# Module stressed input loss calibration and other loss curves

P802.3ck D3.0 comments 202 216 218 223

Piers Dawe, Nvidia

January 2022

Figure 120G-11—Module stressed input target high-loss frequency-dependent attenuator differential-mode to differential-mode insertion loss

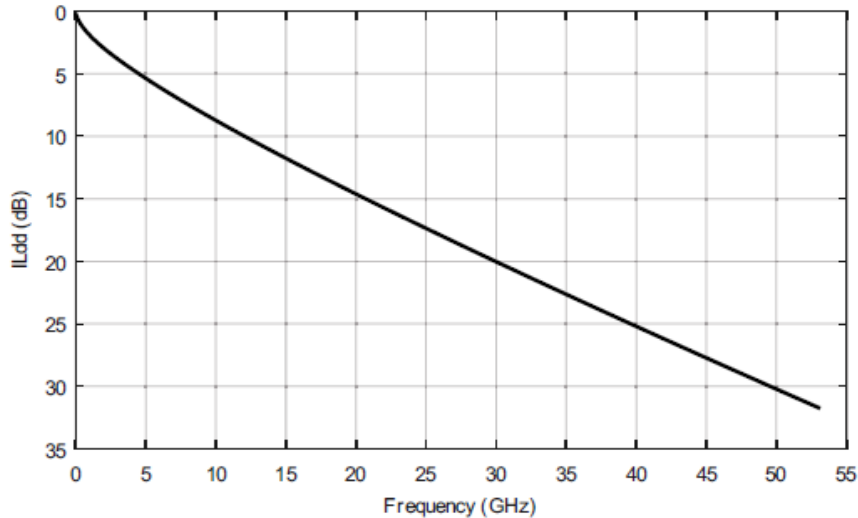
- 18.2 dB at Nyquist
- $IL_{dd}(f) = 1.54\sqrt{f} + 0.3865f$  (120G-3)
- In spite of the figure title, this is not the frequency-dependent attenuator alone

# D3.0

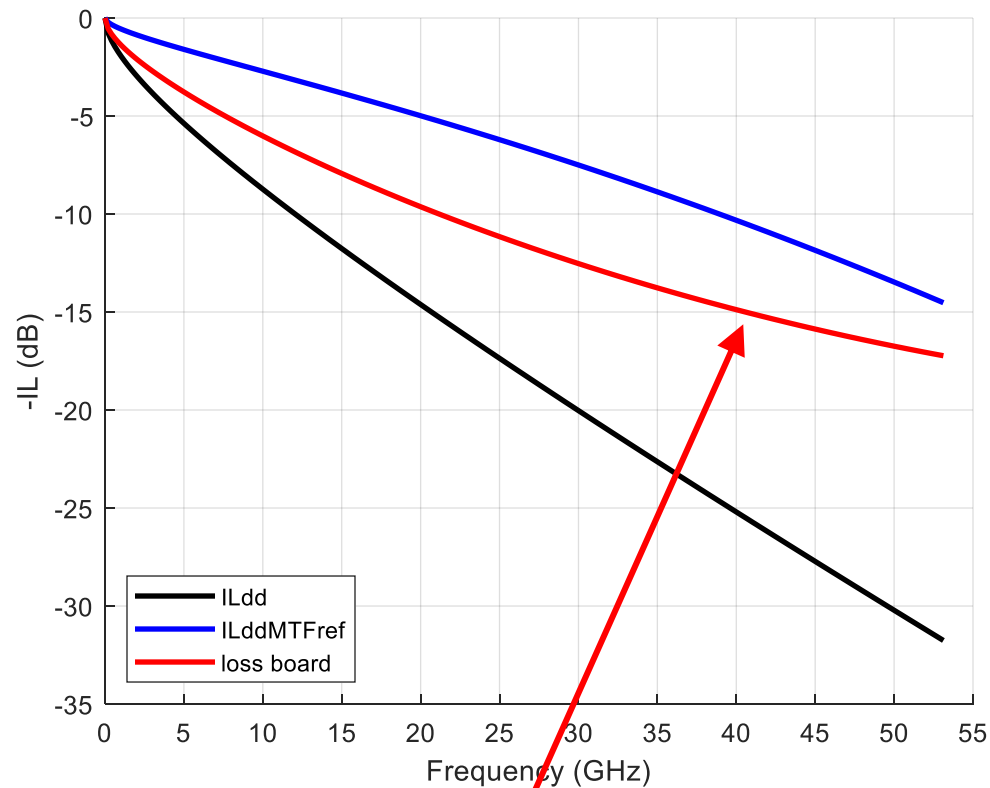
- The mated compliance boards target the blue line
  - $ILddMTFref(f) = 0.942(0.471\sqrt{f} + 0.1194f + 0.002 * f^2)$  Eq 162B–5
  - 6.6036 dB at Nyquist
- So the frequency-dependent attenuator must target the red line which bends too much the **wrong way** ( $f^2$  term with wrong sign)
- Impractical, and not representative of the host-to-module channel and the channels used for module output compliance

# November proposal

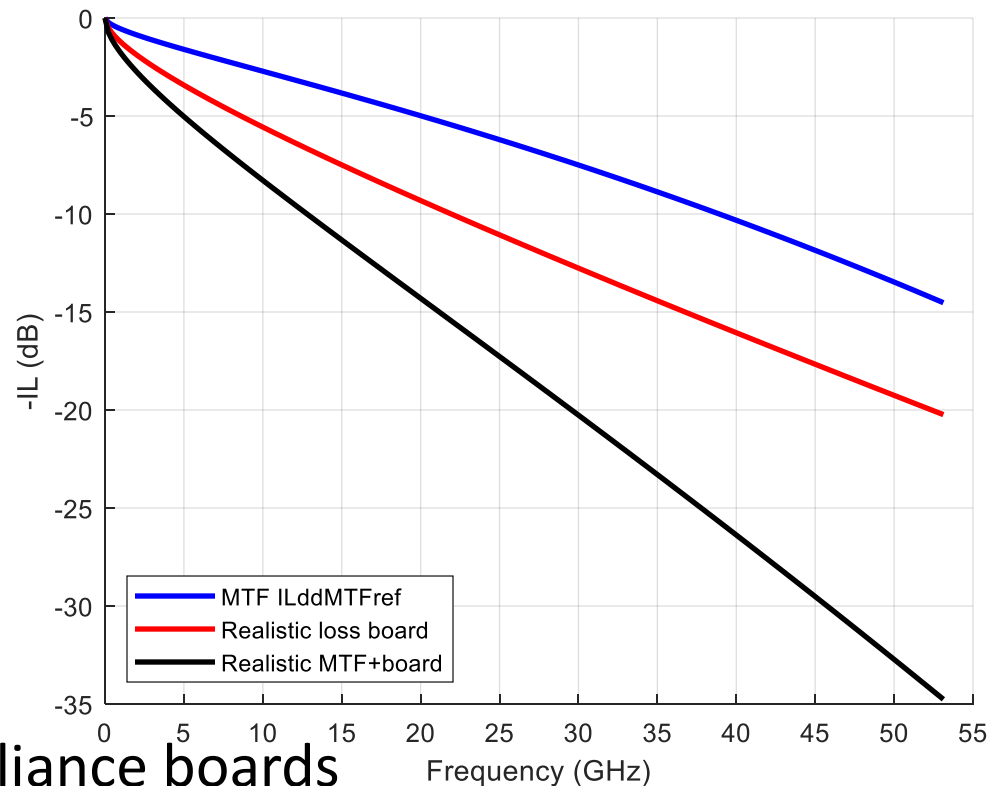
- Blue: mated compliance boards
  - $IL_{ddMTFref}(f) = 0.942(0.471\sqrt{f} + 0.1194f + 0.002*f^2)$  Eq 162B–5
  - 6.6036 dB at Nyquist
- Red: frequency-dependent attenuator
  - $0.980926\sqrt{f} + 0.246243f$  (Eq 120G-3 revised) 11.5964 dB at Nyquist
- Black: total
  - $1.42461\sqrt{f} + 0.358718f + 0.001884*f^2$  18.2 dB at Nyquist
- More practical and representative of the host-to-module channel, **but...**

# Comparing November proposal to D3.0

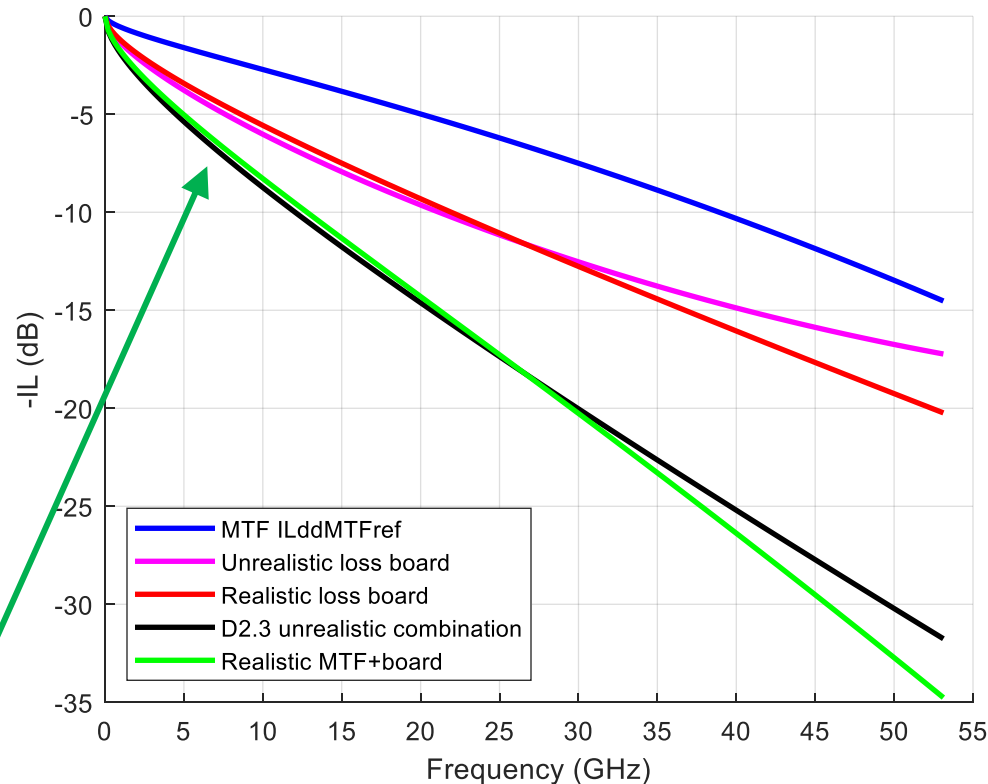
- Green line is better than black line, except not bowed enough at lower frequencies

# Comment 218 Real compliance boards

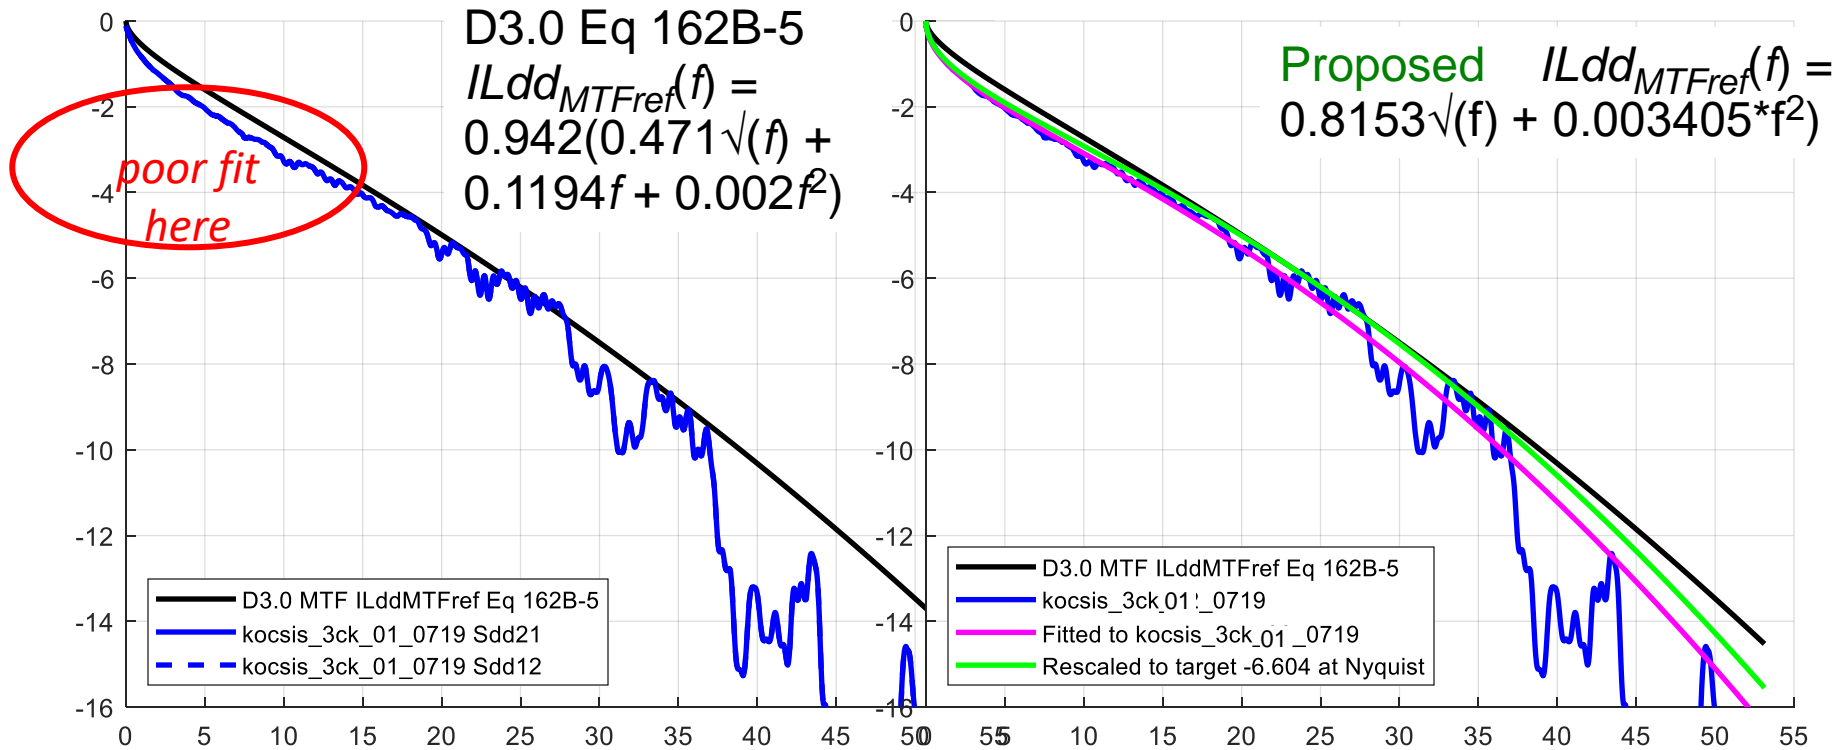
- We don't expect that compliance board traces will get shorter
  - Possibly the opposite as we go from 4 to 8 to maybe 16-wide modules
- But they might use better dielectric, and tolerancing and detailed improvements
- So the low frequency loss will improve less than the high frequency loss

# Associated changes

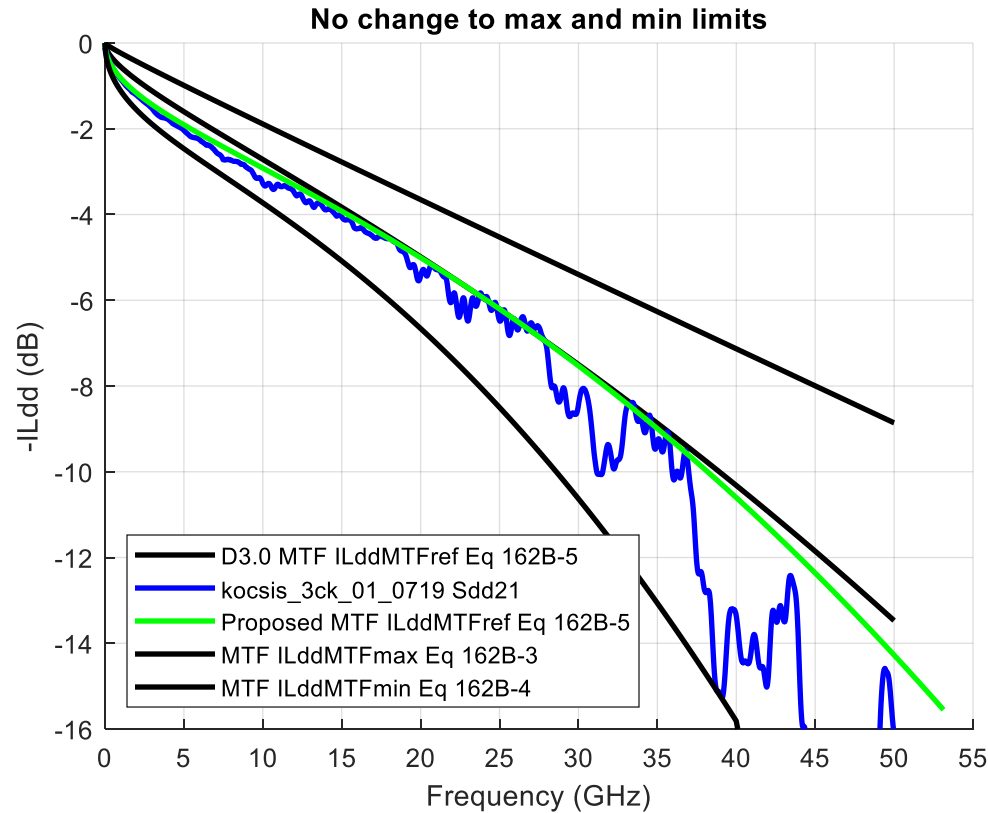
- Max/min mated compliance board limits?
  - No change, see next slide
- For 120G.3.4.3.2 Module stressed input test calibration, high-loss signal calibration *Comment 202*

- Change L from 464 to 295.6 mm
  - Replace Eq 120G-3 with two equations:
  - Frequency-dependent attenuator  $0.981\sqrt{f} + 0.2463f$
  - The loss of the combination is  $1.7962\sqrt{f} + 0.2463f + 0.003405f^2$

- Show all three curves (Eq 162B-5 mated compliance boards, frequency-dependent attenuator and the combination) in Figure 120G-11. Revise its title
- Slightly reduce  $R_{\text{peak}}$  (0.397 in D3.0 Table 162-10)

Figure 163B-1—Example test fixture differential-mode to differential-mode insertion loss

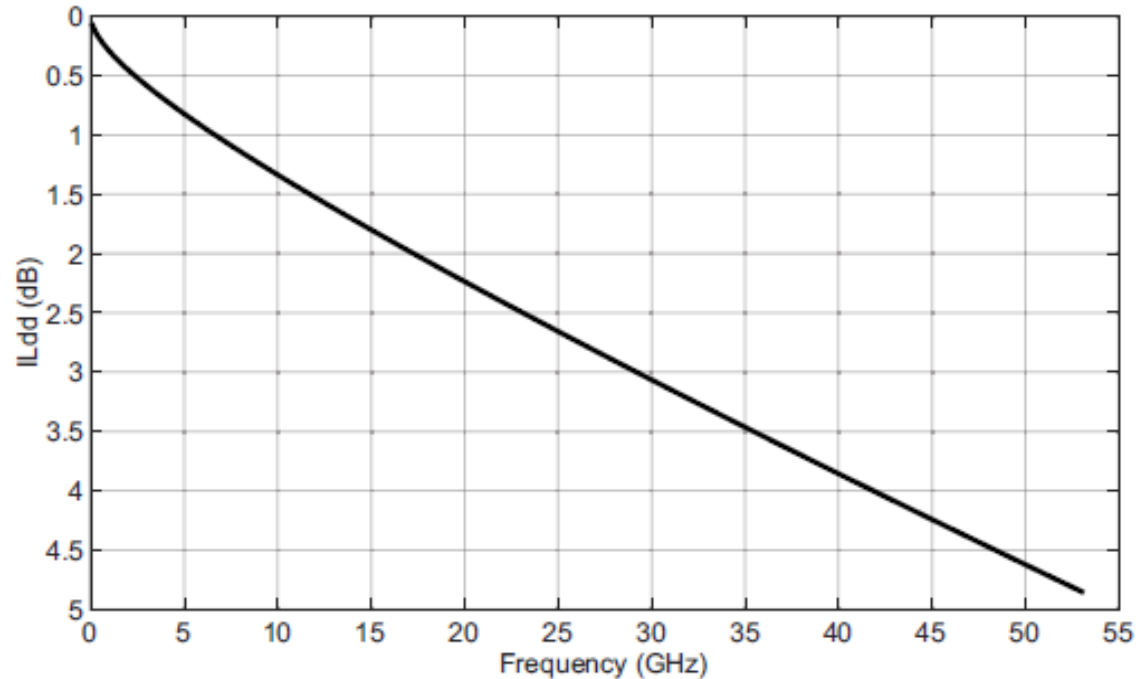
Figure 163B-1 doesn't match Equation 163B-1

- D3.0 Eq 163B-1  $l_{dd}(f) = 0.074 + 0.2104\sqrt{f} + 0.0674f$   $0.05 \leq f \leq 53.125$
- I believe the graph is right, and the right coefficients are 0, 0.235616, 0.059147
- Change to:  $l_{dd}(f) = 0.235616\sqrt{f} + 0.059147f$   $0.05 \leq f \leq 53.125$
